HARTFORD PLANNING COMMISSION

Meeting Notice and Agenda

Re: 444 Sykes Mountain Avenue, Lot 45-243 Site Plan Preliminary Comments

Re: 444 Sykes Mountain Avenue, Lot 45-162 Site Plan Preliminary Comments

S:\PROJECTS\2022\2442 SYKES MT APARTMENTS\DWGS\DWG SHEET FILES\2442 444 SYKES AVE C2.1 SITE PLANNING

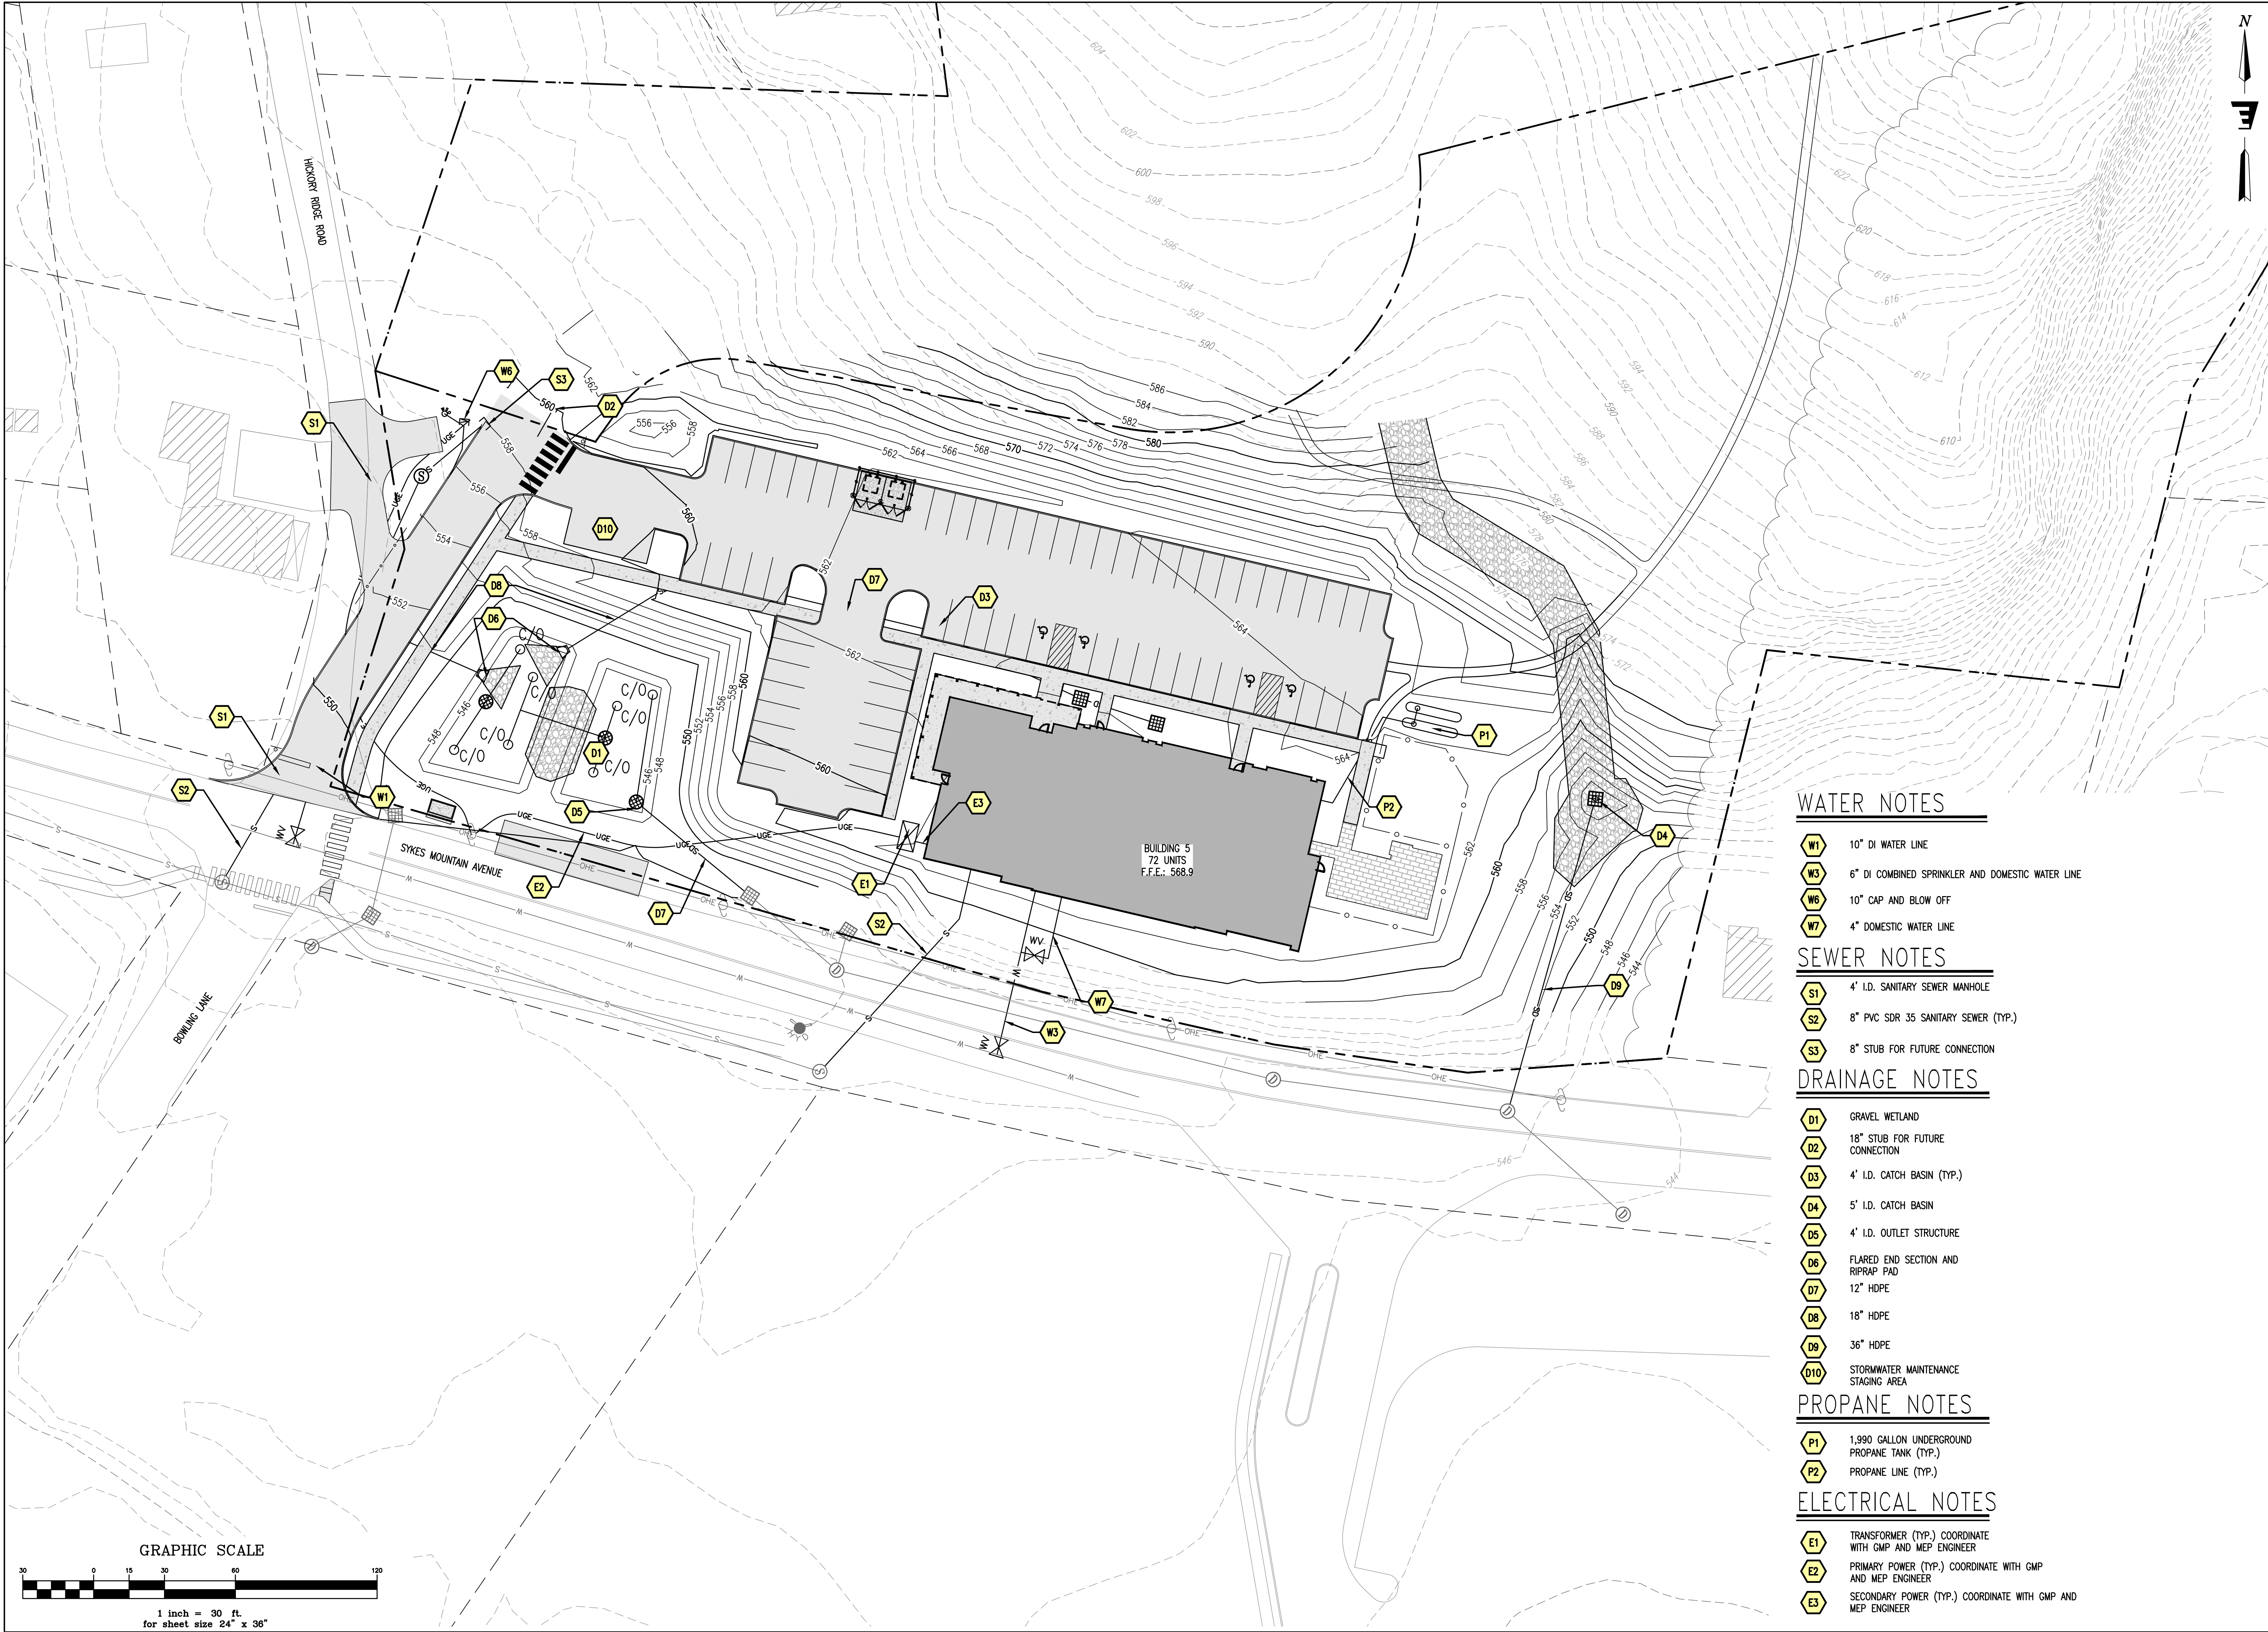
- Exposed foundation needs to match on the civil and architectural plans. The proposed building's first floor elevation has been lowered such that there is no significant exposed foundation.

L1.2

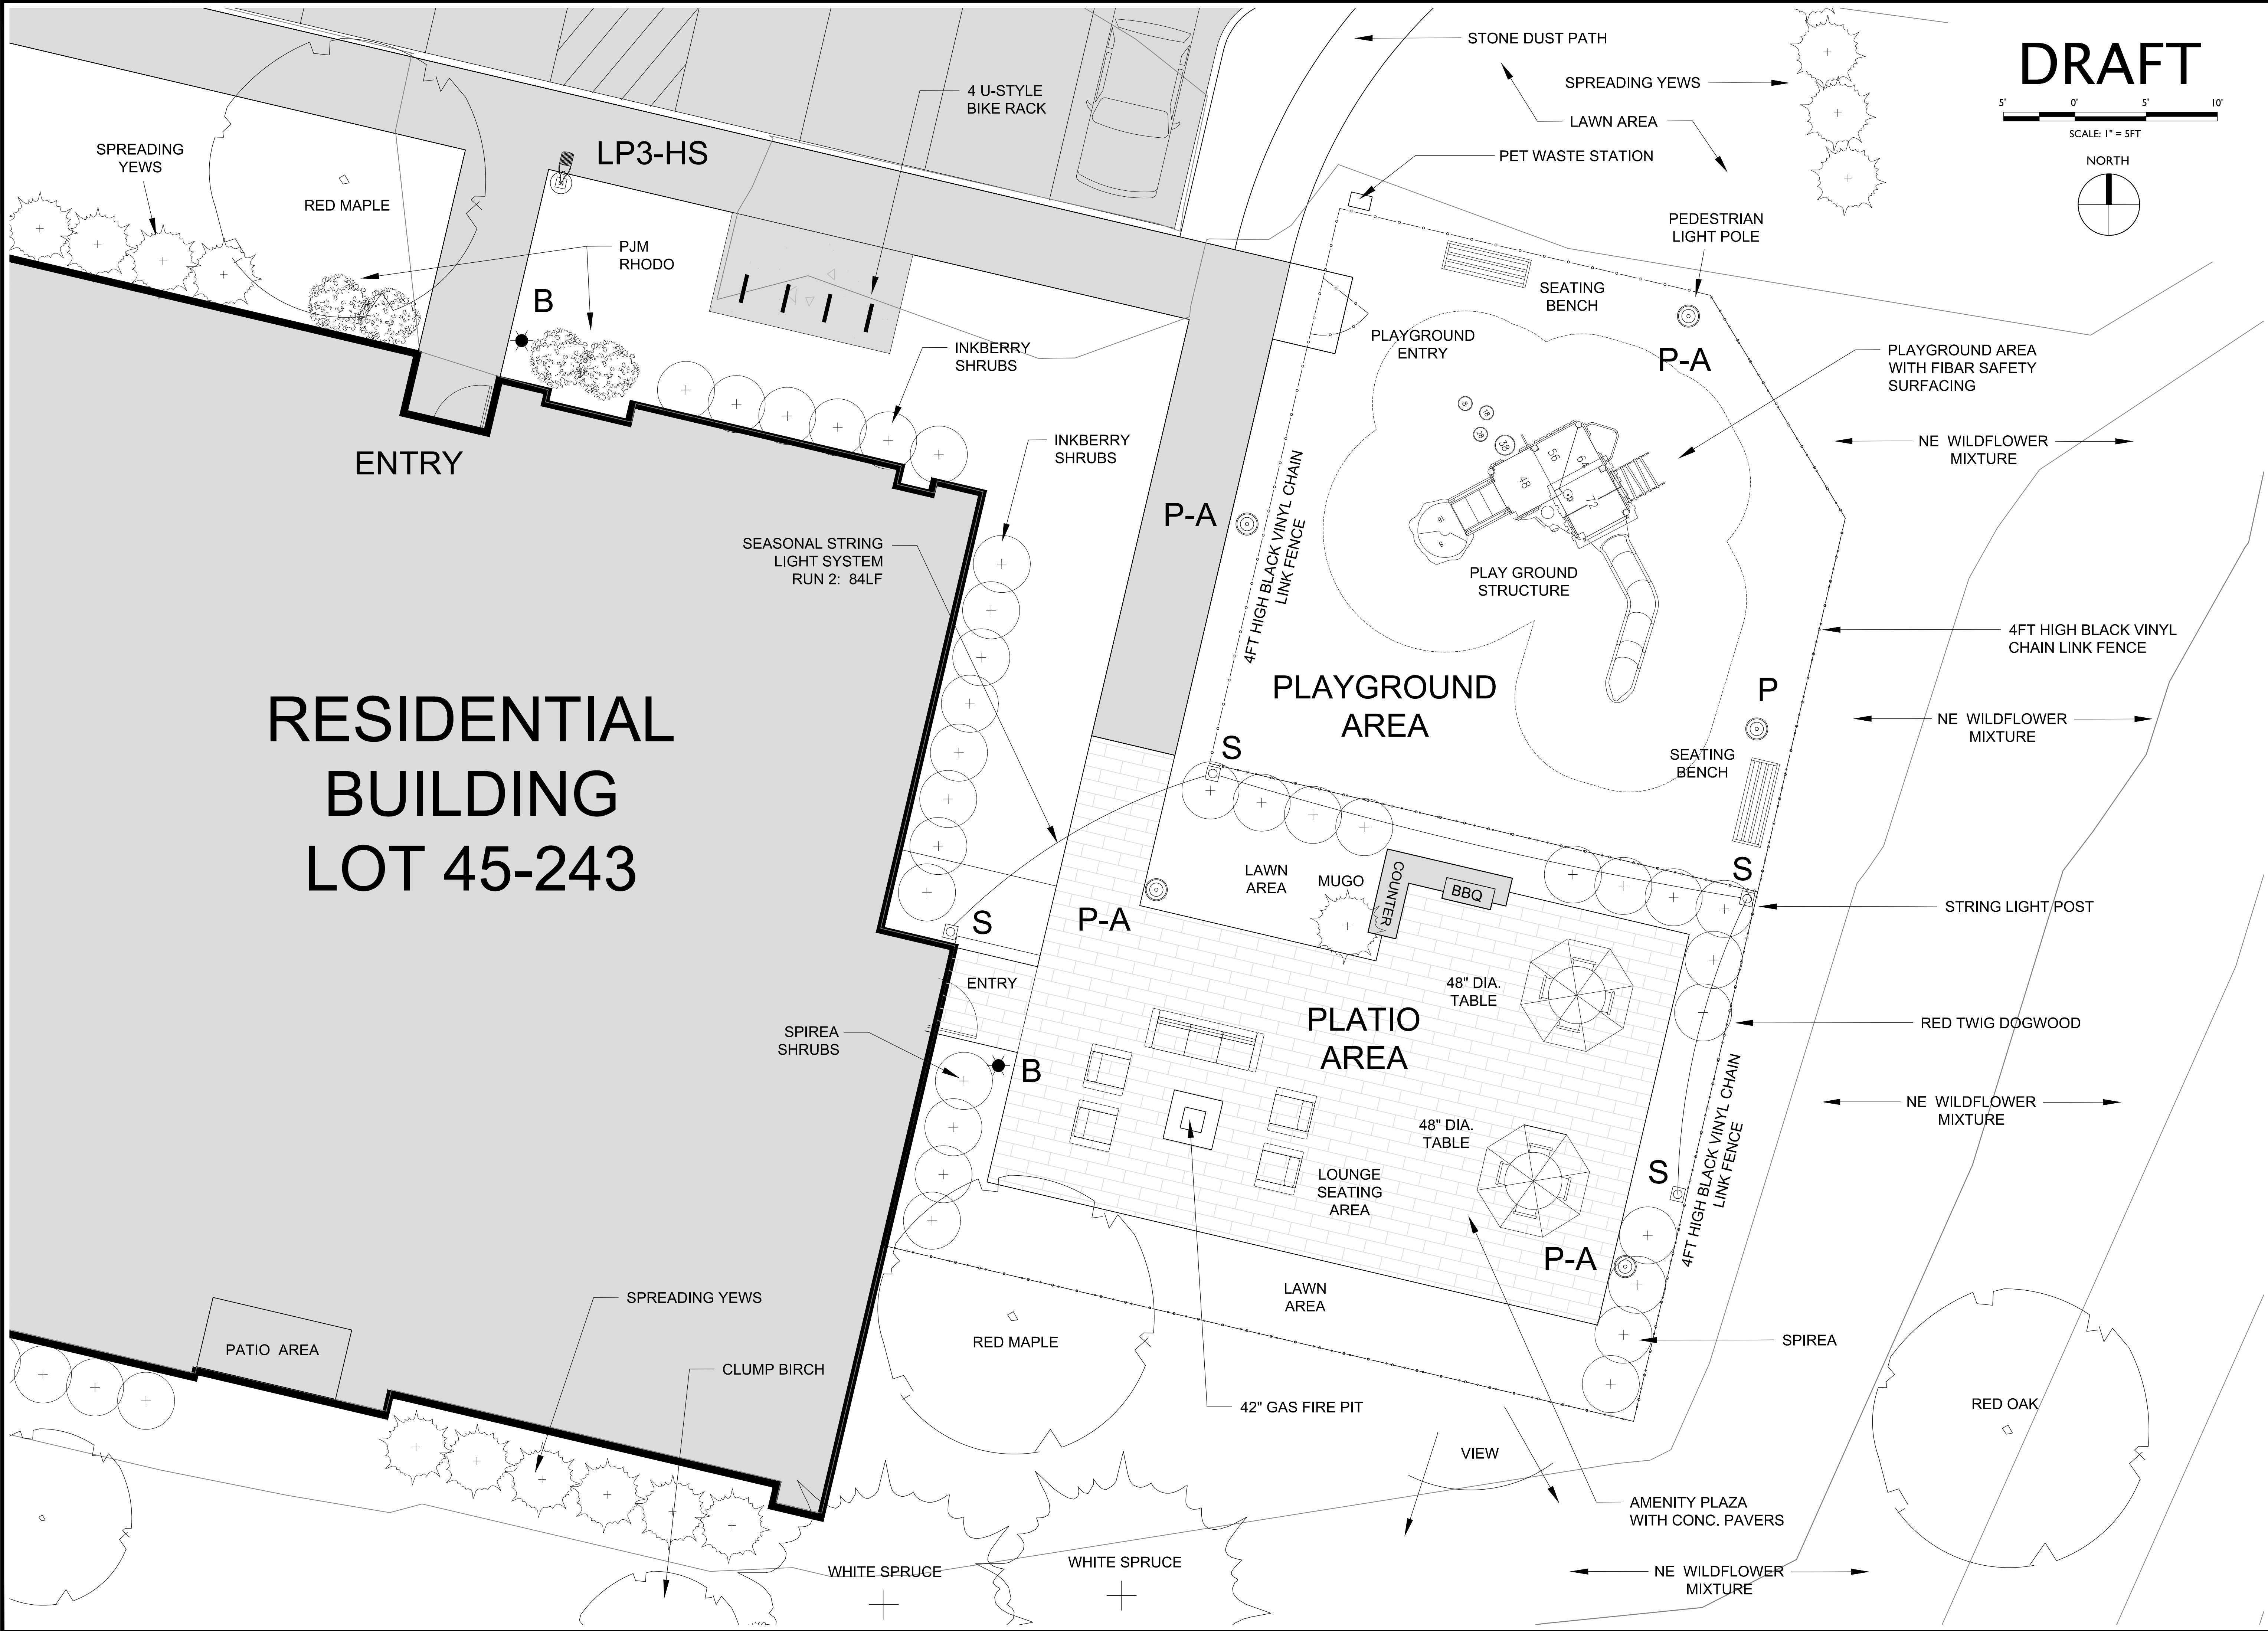
- Like to see a plan with the proposed project on the adjacent lot outlined as “proposed future development.” [Plan L1.0 has been included to depict the Overall Masterplan Concept for both Lots \(highlighting Landscape and Lighting aspects\).](#) We heard from board members the request as to see how both plans work together and believe plan L1.0 will demonstrate both projects.

- Consider taller plantings near the retaining wall and on the north side to screen headlights. The retaining wall along the South Side of the parking area has been removed. The building has now been set further away from Sykes Mountain Avenue (further North) to allow sloped plantings. Regardless of the change with removal of the retaining wall, we have rearranged and redesigned the plantings here with taller plantings (Spruce trees) positioned to flank either side of the building and additionally screen the parking area as requested by the board. NE wildflower mixture will be utilized on all steep slope conditions. (See sheet L1.1)
